## Request for Decision

**Applications for rezoning and plan of subdivision in order to permit the development of a 56 lot residential subdivision and three (3) multi-family blocks with 115 multiple dwelling units (171 units total), Keast Drive, Sudbury - 1721074 Ontario Inc**

Presented To:	Planning Committee
Presented:	Monday, Jun 22, 2015
Report Date	Tuesday, Jun 09, 2015
Type:	Public Hearings
File Number:	751-6/11-6 & 780-6/11003

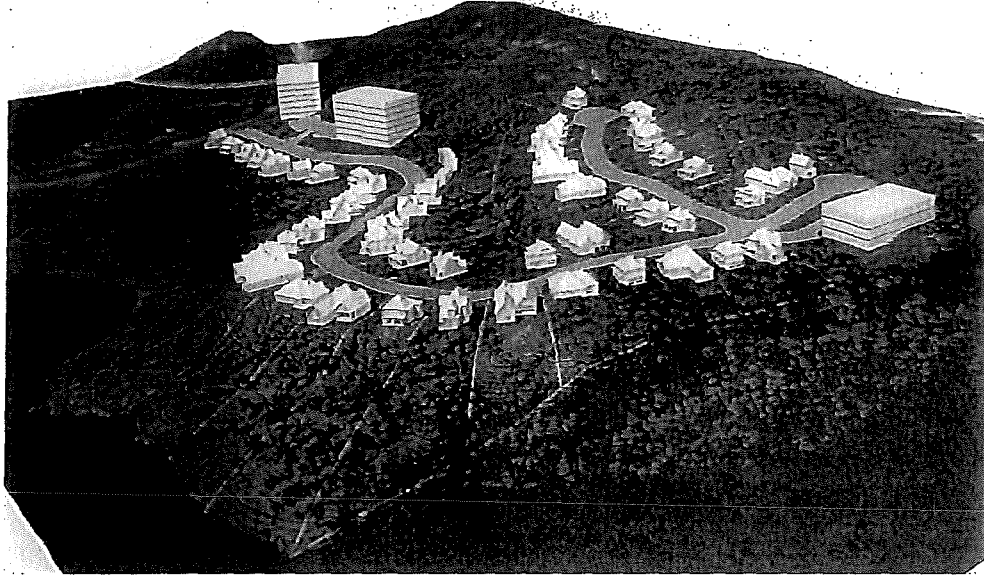
Much of this forest will be removed to make room for homes. Significant blasting will be required to bring water and sewer pipes up this hill. We are concerned that most of this soil, currently held in place by the trees, will eventually be washed into the lake. The steep cliff on lots 13-23 have been designated 'no build zones which should help with some erosion but the slope is so steep and rocky that it may not hold the disrupted soil. The 30 metre shoreline buffer is the recommended minimum by the Ministry of the Environment and the Ministry of Natural Resources with even wider buffers suggested for steep shorelines. (Lakeshore Capacity Assessment Handbook, May 2010.) A natural wetland will be replaced with a stormwater pond. The wildlife habitat of animals in the forest and wetland will not be preserved. One feature that will be preserved is the Creighton Fault in Block B.

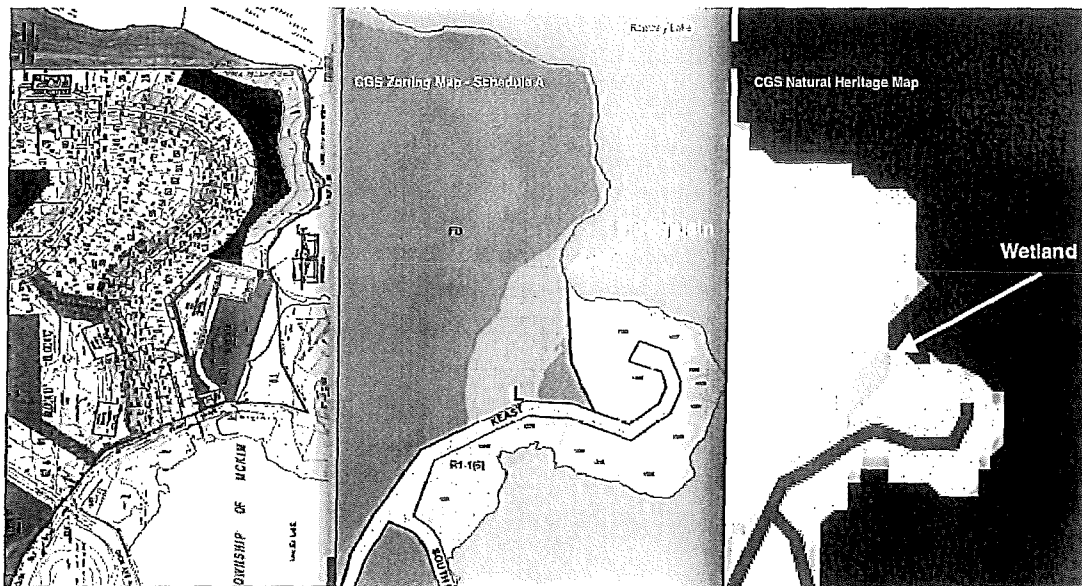
Furthermore, the Ministry of the Environment, in its Stormwater Management Planning and Design manual (2003), states that as a general rule, stormwater facilities should be located **outside the floodplain**. Only under very special circumstances and if a number of requirements are met, would using up a part of the floodplain be acceptable. For this proposed development, the stormwater management facility is in a floodplain. Should flooding occur, all the untreated water would enter the lake bringing with it the pollutants found in road runoff such as heavy metals, bacteria, nutrients, grease, oil, pesticides, and sediments.

A sewage lift station (red L) is also proposed to be built in the floodplain against MOE guidelines. When sewage lift stations overflow, the result is raw sewage spilling out. We have concerns that a lift station would be proposed in a floodplain.

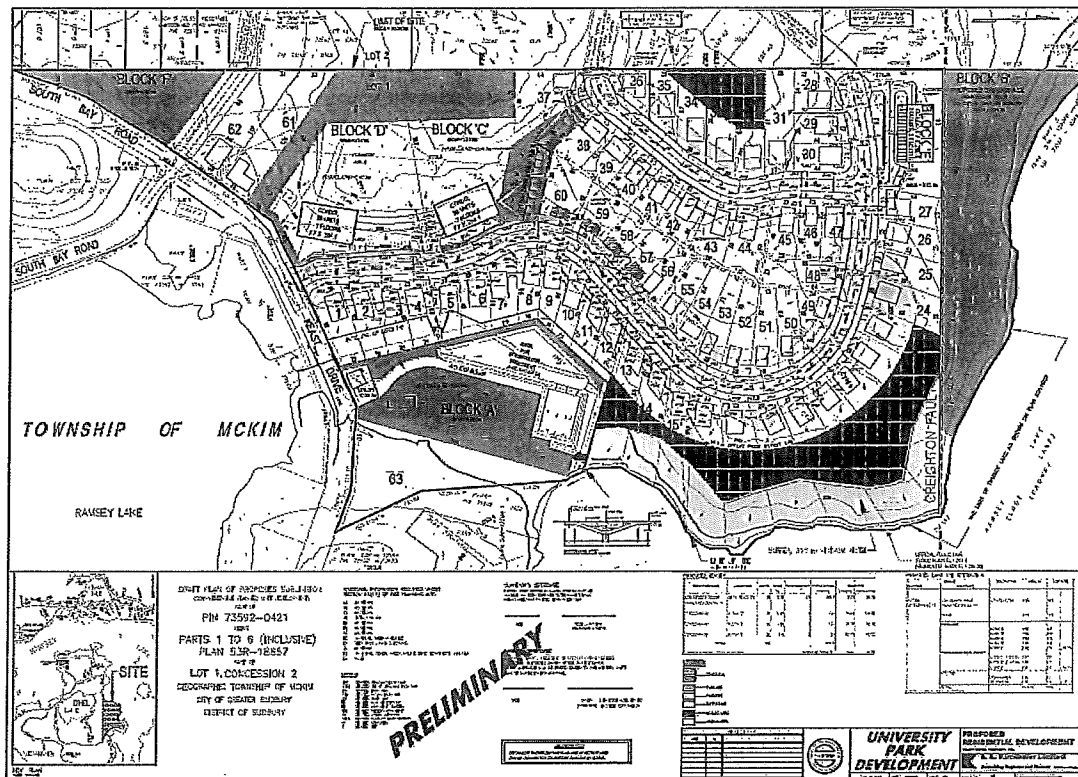
In this proposed development, homes 1-5 are in the current floodplain, so the land will require infilling, which will alter the floodplain.

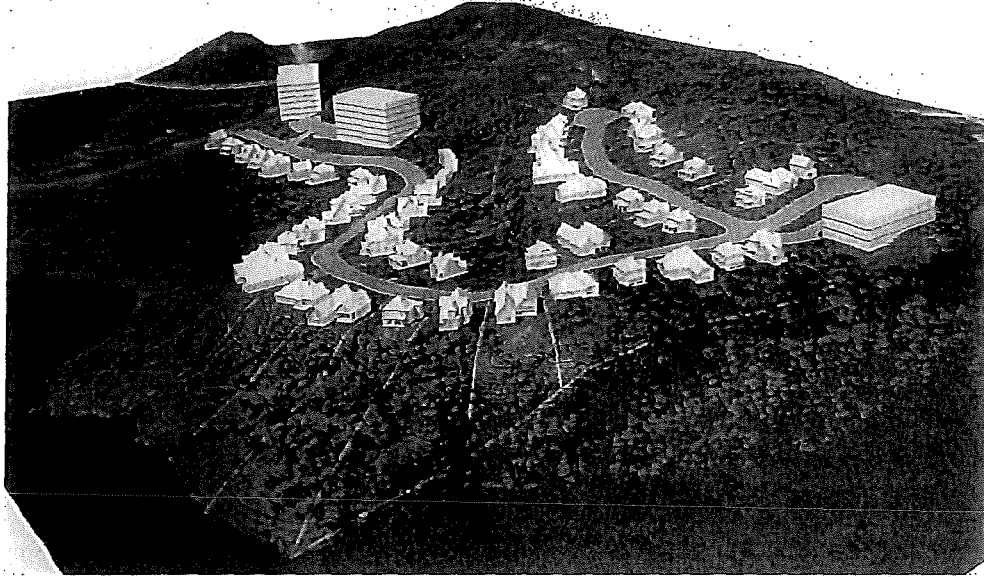
Much of this forest will be removed to make room for homes. Significant blasting will be required to bring water and sewer pipes up this hill. We are concerned that most of this soil, currently held in place by the trees, will eventually be washed into the lake. The steep cliff on lots 13-23 have been designated 'no build zones' which should help with some erosion but the slope is so steep and rocky that it may not hold the disrupted soil. The 30 metre shoreline buffer is the recommended minimum by the Ministry of the Environment and the Ministry of Natural Resources with even wider buffers suggested for steep shorelines. (Lakeshore Capacity Assessment Handbook, May 2010.) A natural wetland will be replaced with a stormwater pond. The wildlife habitat of animals in the forest and wetland will not be preserved. One feature that will be preserved is the Creighton Fault in Block B.

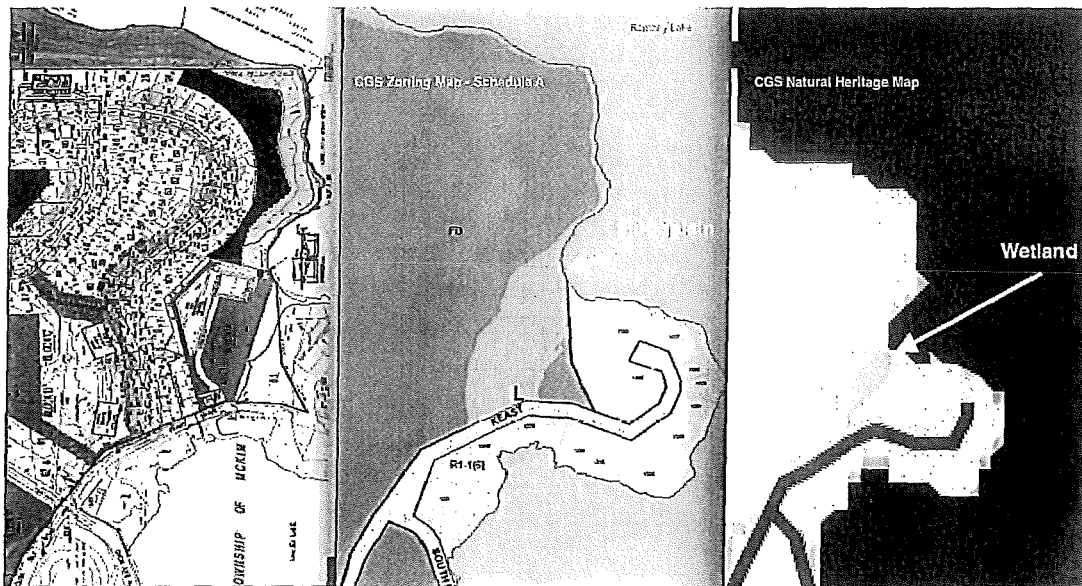
Furthermore, the Ministry of the Environment, in its Stormwater Management Planning and Design manual (2003), states that as a general rule, stormwater facilities should be located **outside the floodplain**. Only under very special circumstances and if a number of requirements are met, would using up a part of the floodplain be acceptable. For this proposed development, the stormwater management facility is in a floodplain. Should flooding occur, all the untreated water would enter the lake bringing with it the pollutants found in road runoff such as heavy metals, bacteria, nutrients, grease, oil, pesticides, and sediments.

A sewage lift station (red L) is also proposed to be built in the floodplain against MOE guidelines. When sewage lift stations overflow, the result is raw sewage spilling out. We have concerns that a lift station would be proposed in a floodplain.

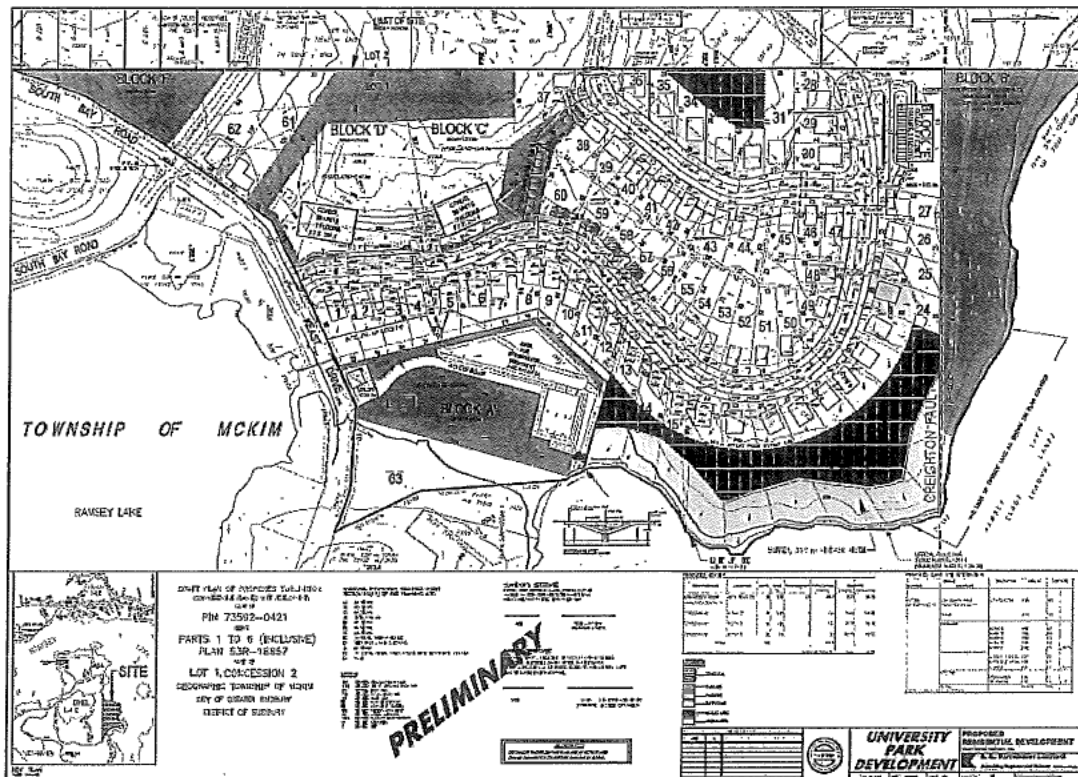
In this proposed development, homes 1-5 are in the current floodplain, so the land will require infilling, which will alter the floodplain.

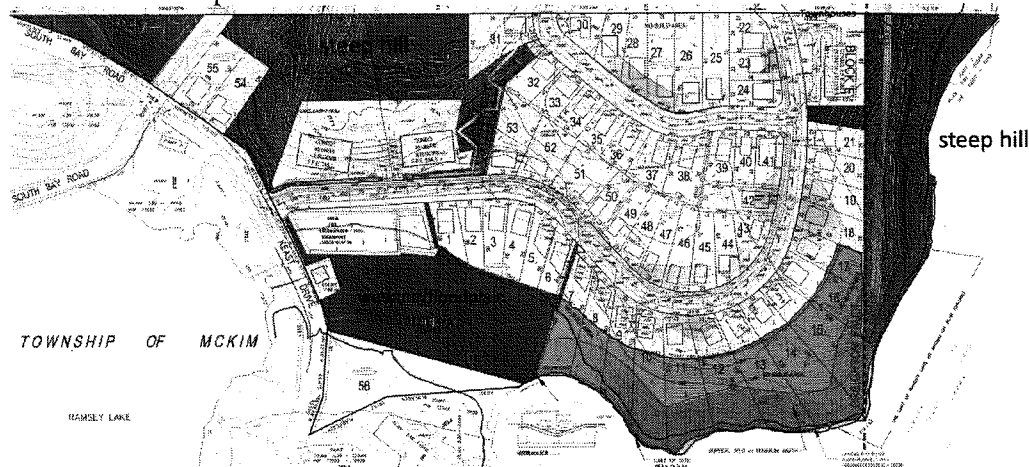
No linked trail is proposed. Much of the green blocks are separated by roadways or homes. Staff indicates, in their report, that most of the greenspace land is not unusable, is steep, difficult to reach or is a wetland in a floodplain, which all should not be considered **useable** parkland. We propose the 'No Build Area' and 30m shoreline buffer be allocated as greenspace (light green below) for a small trail and linkage between Block B and Block A. Adding this area to city greenspace will help fulfill these two requirements of the CPUD.

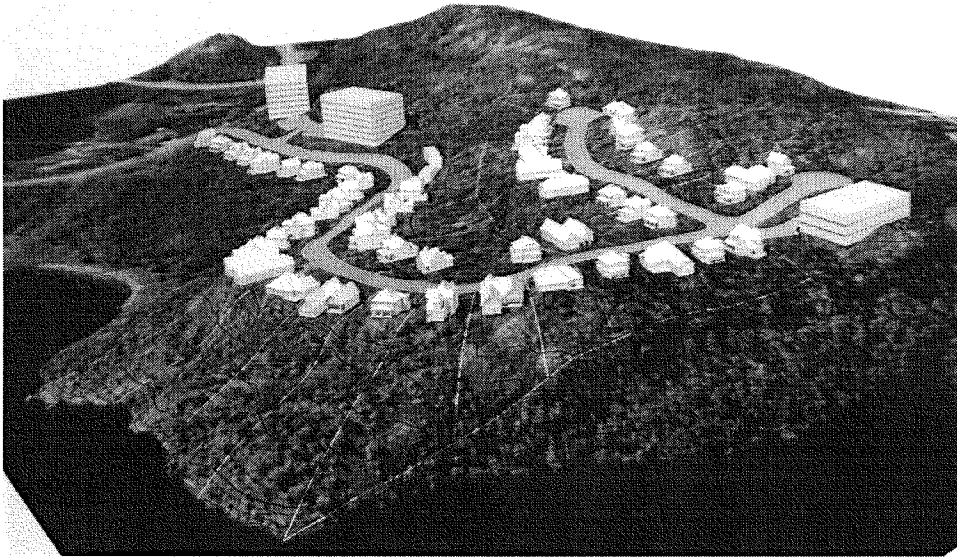
<sup>4</sup> This diagram shows the 2 condos near South Bay Road at 7 storeys and the one overlooking Bethel Lake at 3.

<sup>5</sup> Calling this housing area, University Park, does not reduce the problem of towering condos that dominate the landscape for Ramsey Lake and Bethel Lake. The name seems to join this area with the university. If the university were considered, the size of the condos might seem reasonable, there is quite a distance between the university and this area with many single-dwelling units in-between.
